# Addendum to Preliminary & Final Drainage Report

## **Sanctuary of Peace Residential Community**

**Project Number 61087**

**PCD Proj # SF-21-27**

EXISTING DRAINAGE MAP

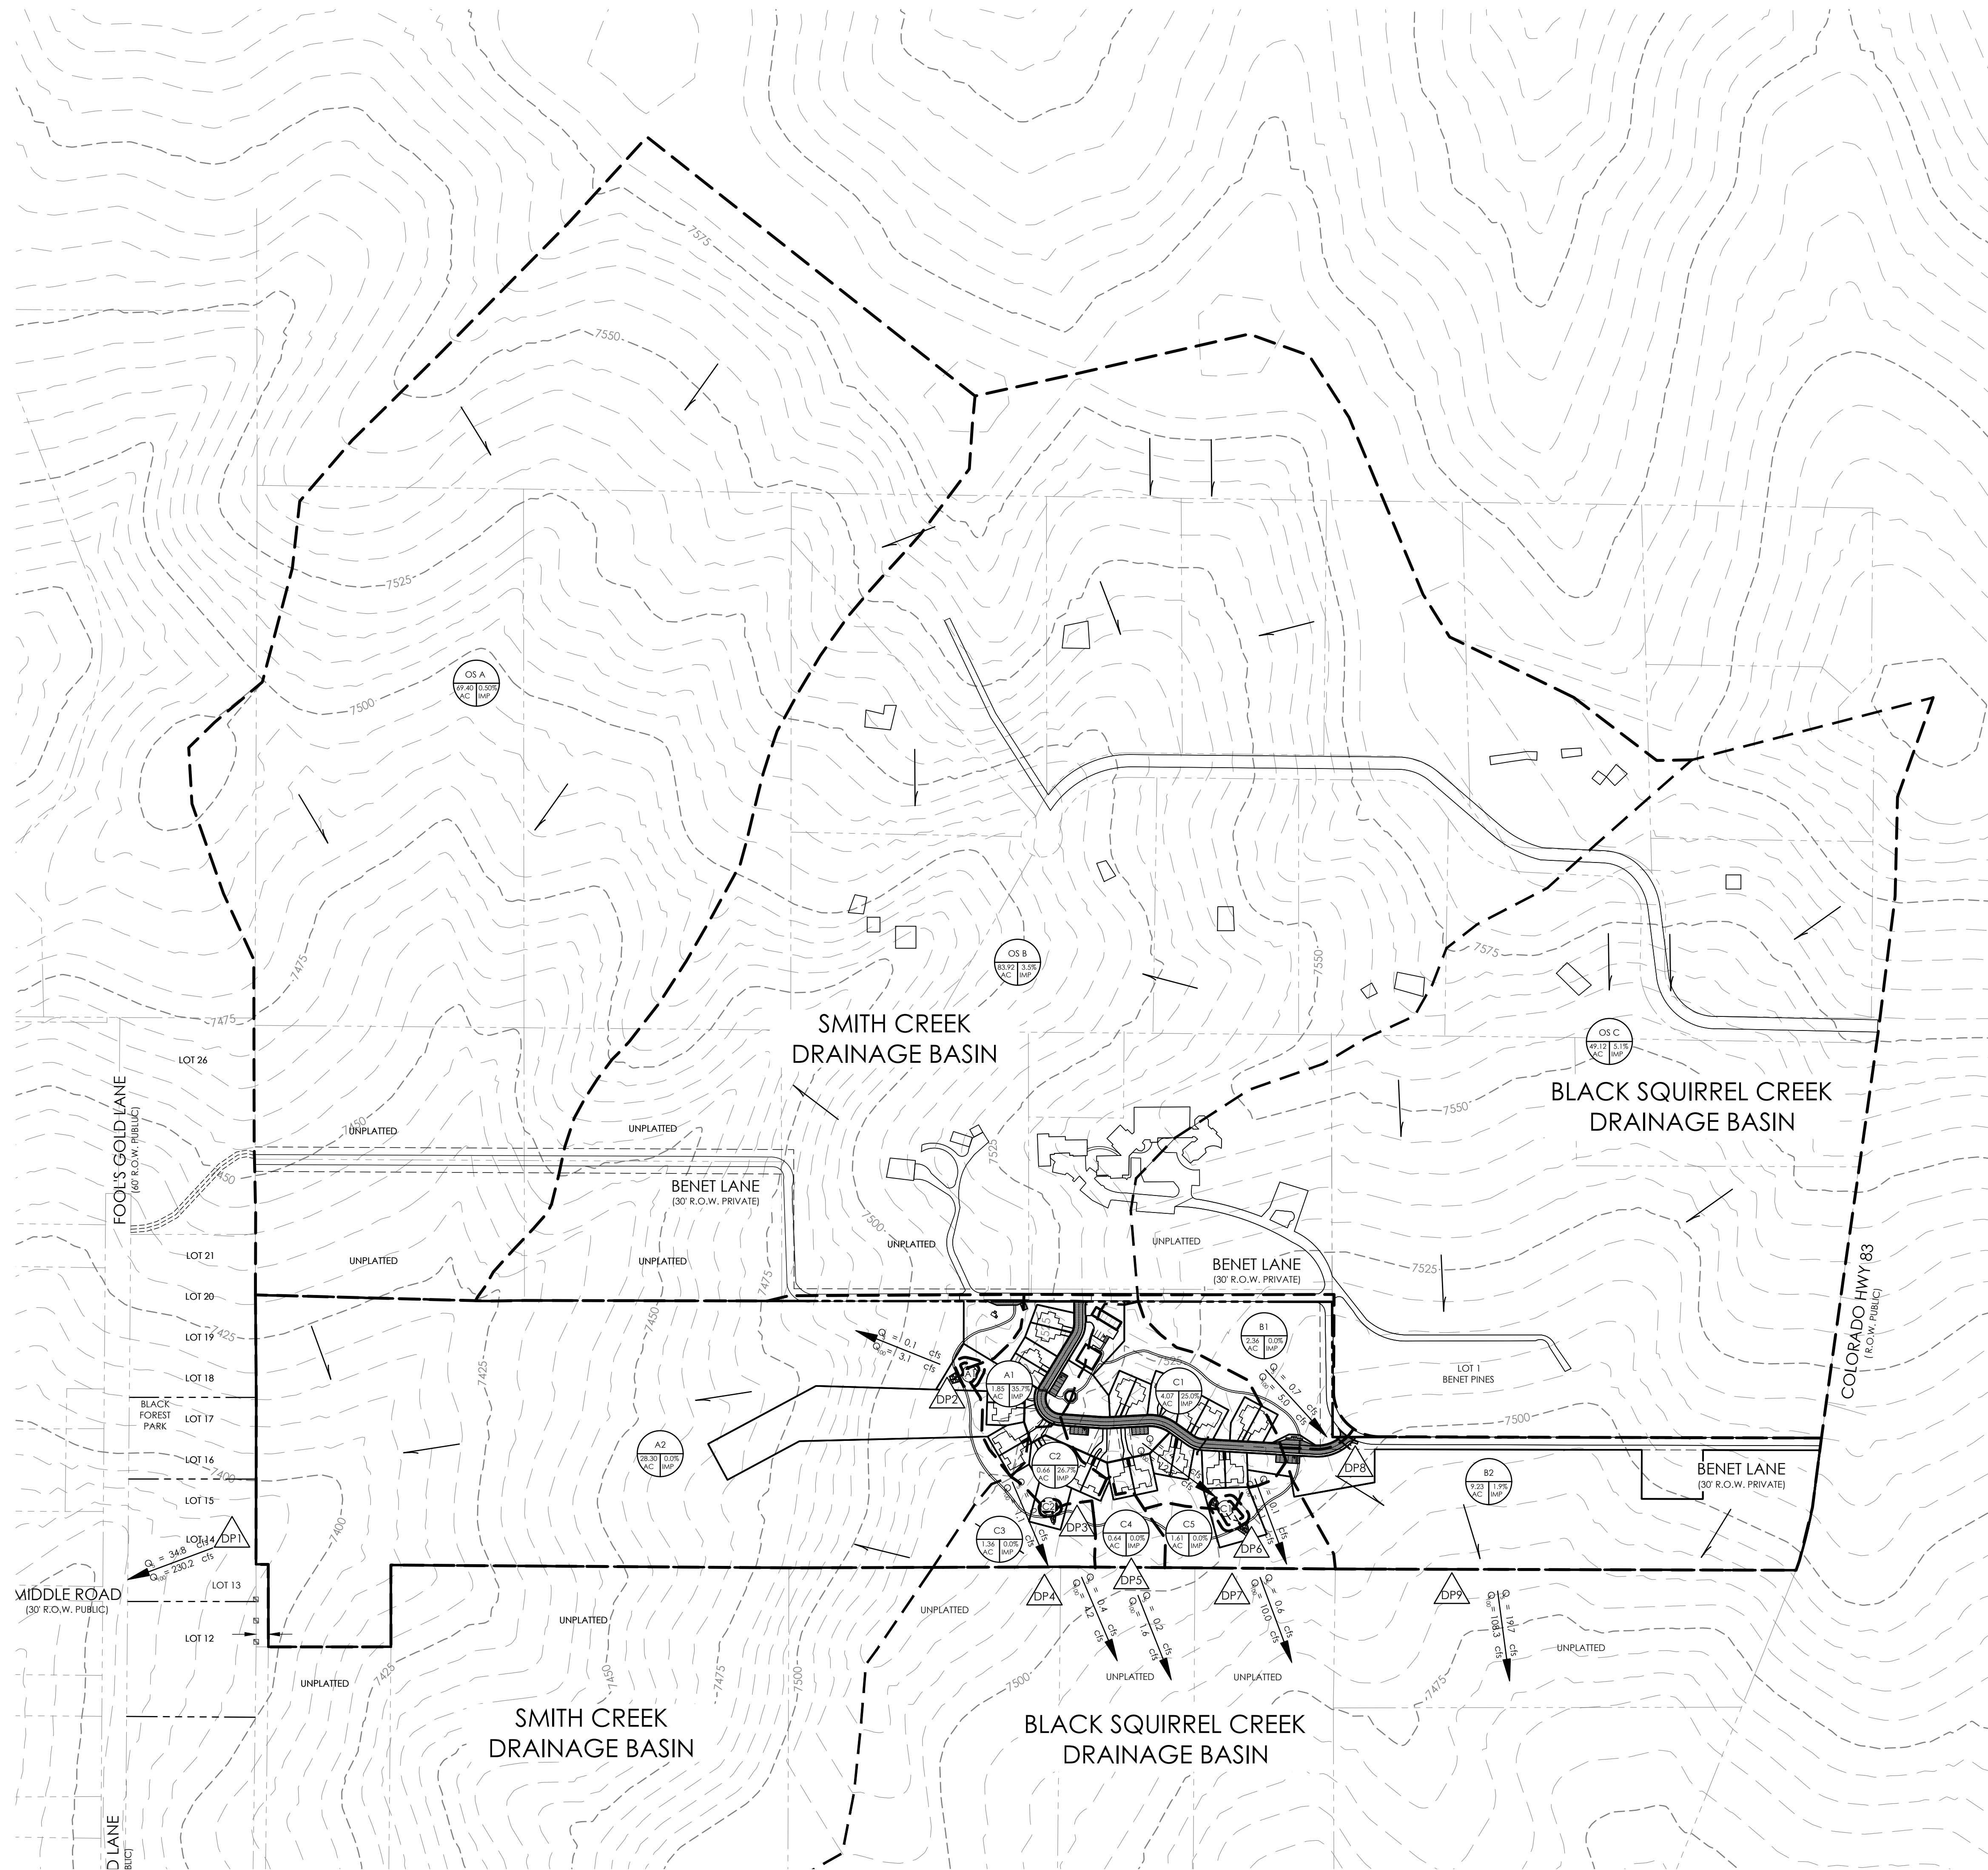
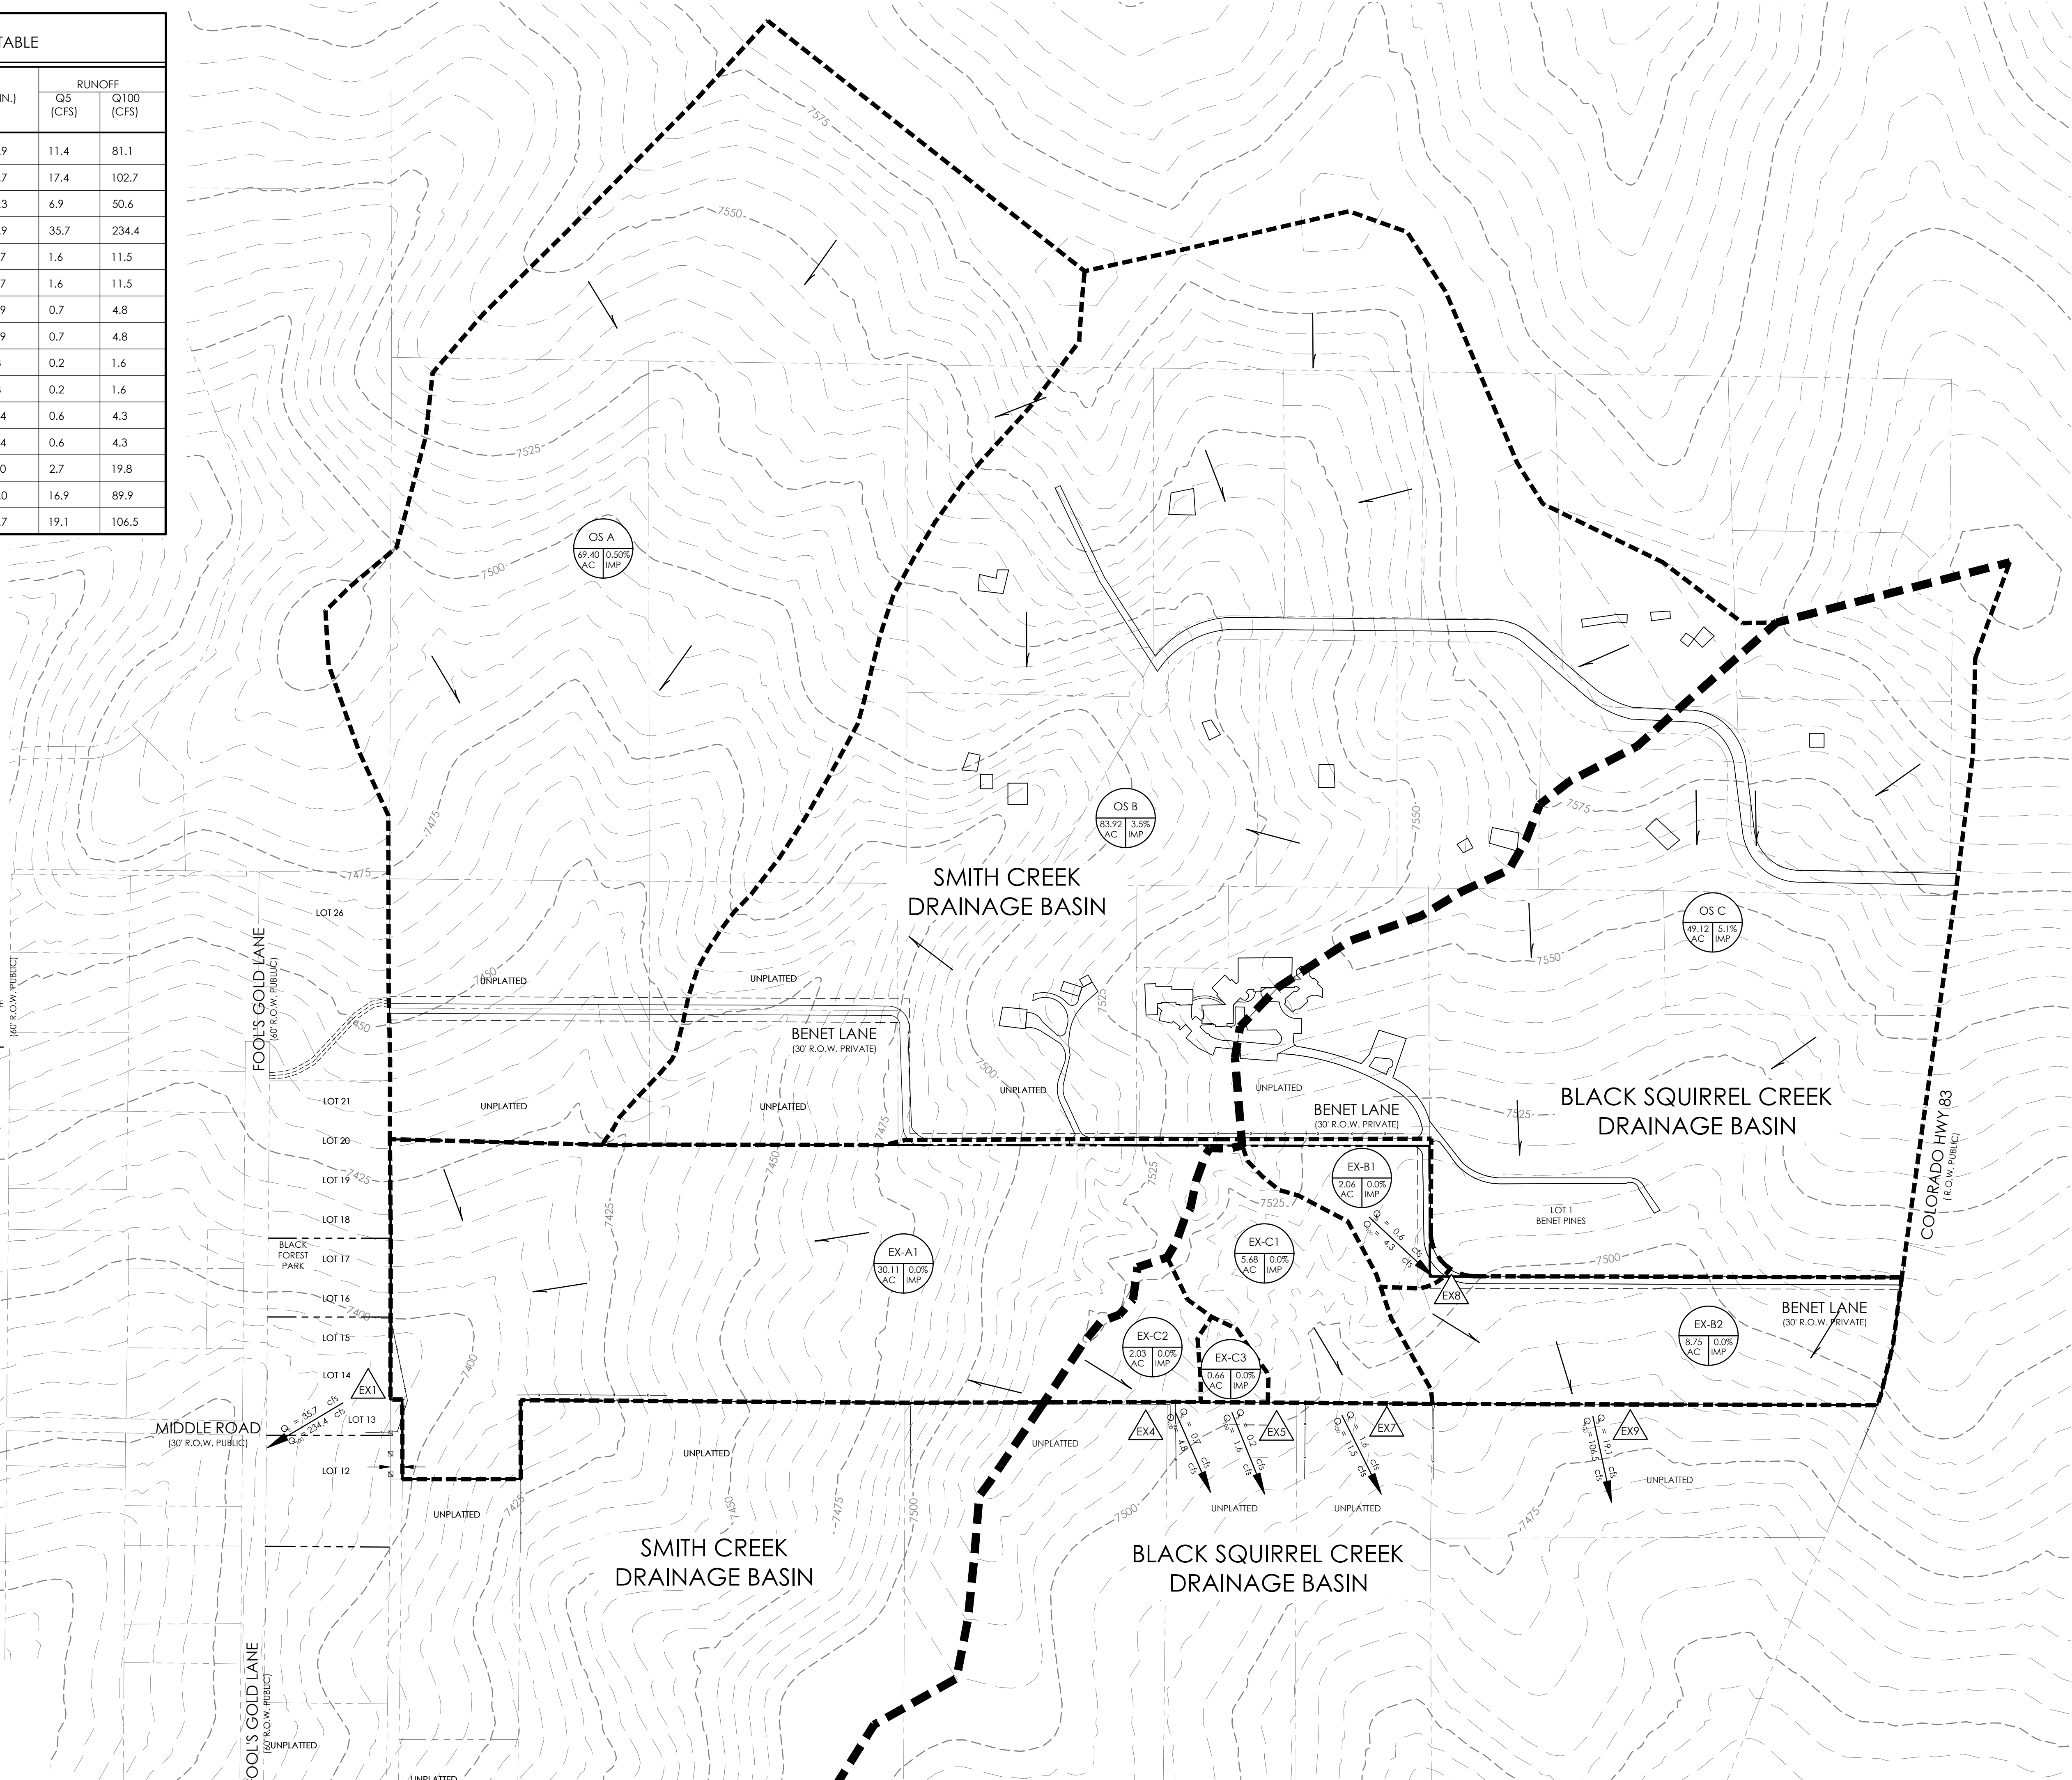
**The existing flows at DP EX9, which includes sub-basins OS C, EX-B1 and EX-B2 are 19.1 cfs and 106.5 cfs for the 5-year and 100-year rainfall recurrence intervals, respectively. Developed Condition** Design Point DP9 has storm water flows from Drainage Basin OS C and will flow overland to Benet Lane (private drive) and under Benet Lane via existing culverts. These storm water flows will combine with DP8 and overland flows from Basin B2. This area remains in its existing state of forested land. The rate of flow is  $Q_5 = 19.7$  cfs and  $Q_{100} = 108.3$  cfs and exits the site along its southerly boundary designated as Point of Interest DP9. **This represents minor changes in flow rates of 0.6 cfs in the 5-year and 1.8 cfs in the 100-year events.**

EXISTING DRAINAGE SUMMARY TABLE					
DESIGN POINT	BASIN	AREA (AC)	Tc (MIN.)	RUNOFF	
				Q5 (CFS)	Q100 (CFS)
	OS A	69.40	41.9	11.4	81.1
	OS B	83.92	41.7	17.4	102.7
	EX-A1	30.11	23.3	6.9	50.6
EX1	OS A, OS B, EX-A1	153.32	41.9	35.7	234.4
	EX-C1	5.68	15.7	1.6	11.5
EX7	EX-C1	5.68	15.7	1.6	11.5
	EX-C2	2.03	10.9	0.7	4.8
EX4	EX-C2	2.03	10.9	0.7	4.8
	EX-C3	0.66	9.8	0.2	1.6
EX5	EX-C3	0.66	9.8	0.2	1.6
	EX-B1	2.06	14.4	0.6	4.3
EX8	EX-B1	2.06	14.4	0.6	4.3
	EX-B2	8.75	12.0	2.7	19.8
	OS C	49.12	23.0	16.9	89.9
EX9	EX-B1, EX-B2, OS C	59.93	23.7	19.1	106.5
